**COUNTY OF SAN LUIS OBISPO  
DEPARTMENT OF PLANNING AND BUILDING  
STAFF REPORT**

MEETING DATE August 11, 2005	CONTACT/PHONE Brian Pedrotti 788-2788	APPLICANT Cathy MacGregor	FILE NO. DRC2003-00043
SUBJECT Request by Cathy MacGregor for a Minor Use Permit to allow a winery building including wine processing, barrel storage, and tasting room. The project will result in the disturbance of approximately one acre of a 24.9 acre parcel. The proposed project is within the Agriculture land use category and is located at the northwest corner of the intersection of Price Canyon Road and Edna Road, south of Old Price Canyon Road at 1600 Old Price Canyon Road, approximately 2.5 miles south of the City of San Luis Obispo. The site is in the San Luis Obispo planning area.			
RECOMMENDED ACTION Deny Conditional Use Permit DRC2003-00043 based on the findings listed in Exhibit A			
ENVIRONMENTAL DETERMINATION That this project is found to be statutorily exempt from the California Environmental Quality Act under the provisions of Public Resources Code section 21080(b)(5), which provides that CEQA does not apply to projects which a public agency rejects or disapproves.

**FINDINGS - EXHIBIT A**

Site Plan

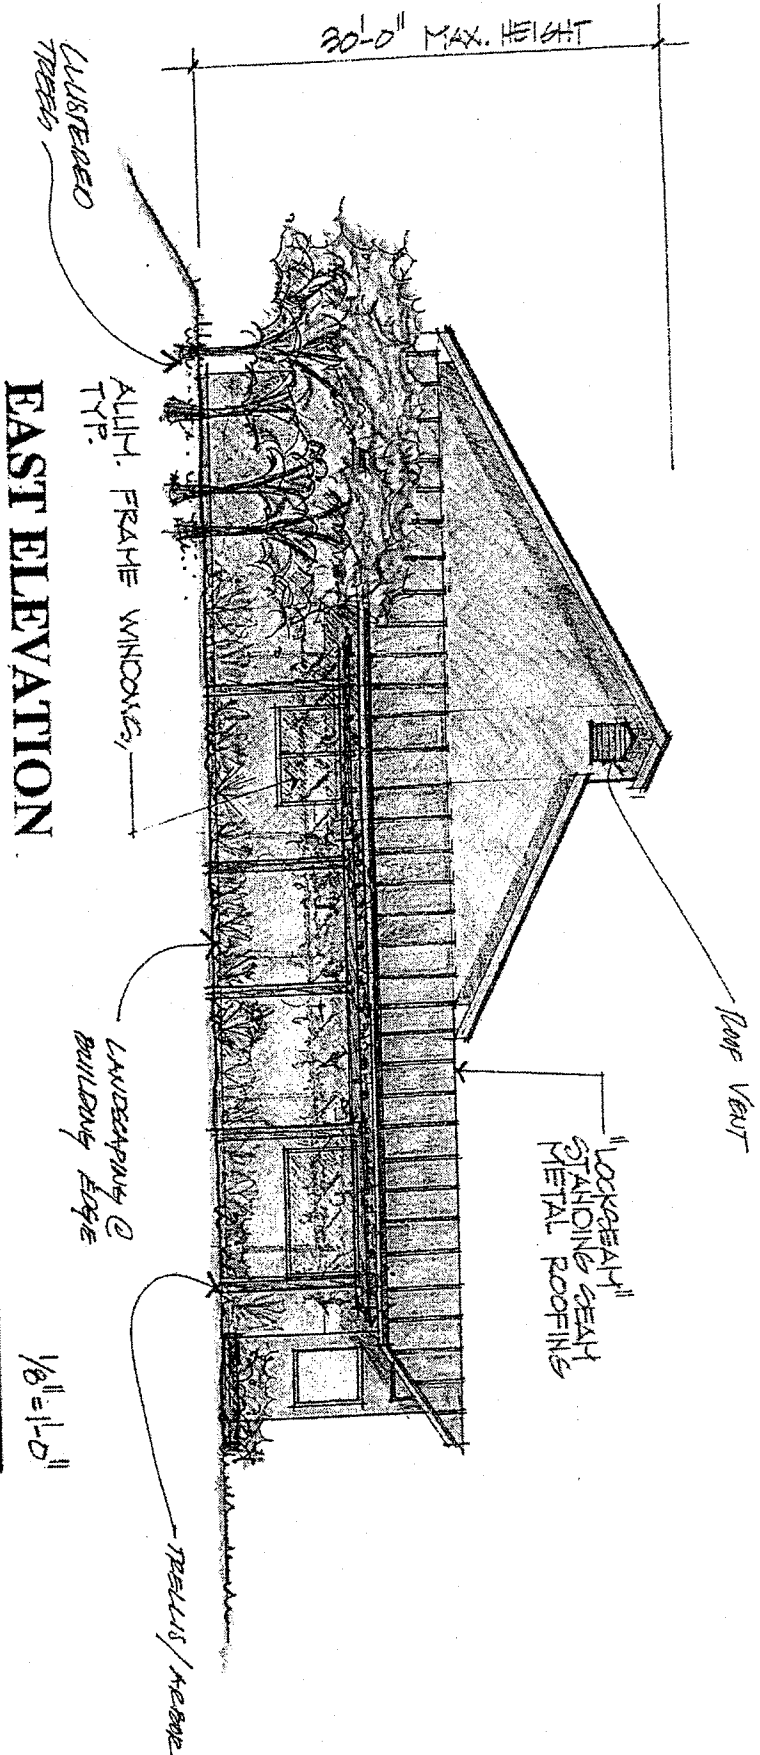
Discussion: The development, including the water tank, is proposed on the most visible portion of the site from Highway 227. Very limited topographic features are available at the top of the hill for screening purposes; rather, vegetative screen has been proposed.

Discussion: Grading of the site is not minimized due to the CDF required 20' wide access driveway that is proposed to provide access to the top of the hill, as well as the parking lot and production areas on top of the hill. Significant cut and fill slopes will result from the grading and will be highly visible. Revegetation of any resulting cut/fill slopes may be difficult due to the limited depth of soil layer on the hill.

Discussion: Grading for roads is proposed on slopes approaching 45%.

Elevation

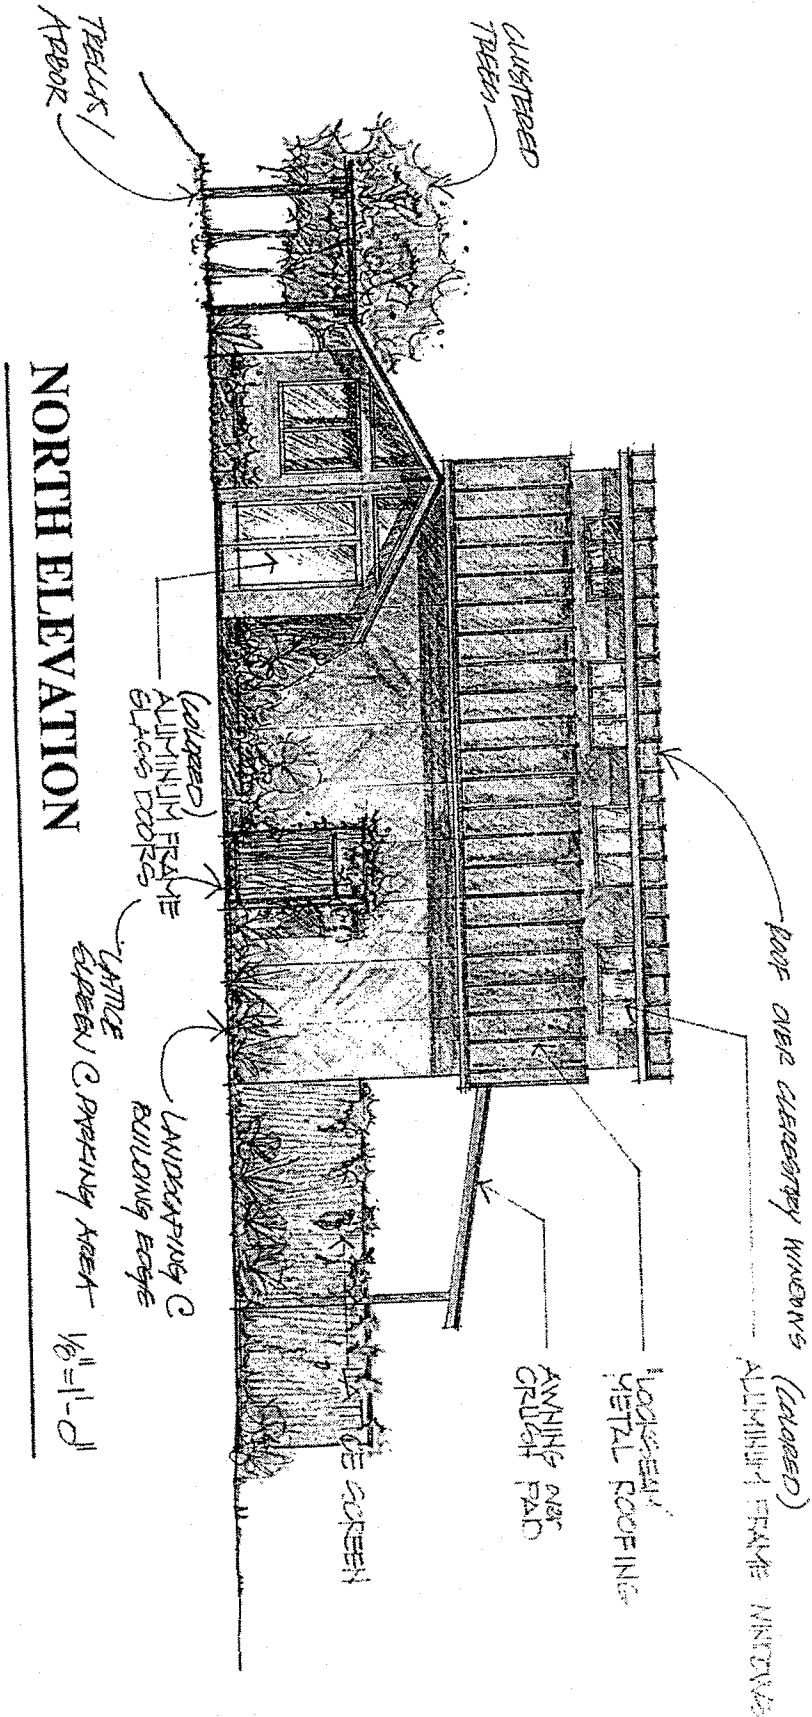
Discussion: The proposed development is approximately 30 feet in height and will be highly visible from public roads. A one-story structure is typically around 15 feet in height. The proposed 25,000 gallon water tank will also be highly visible. No height has been provided for the proposed water tanks.
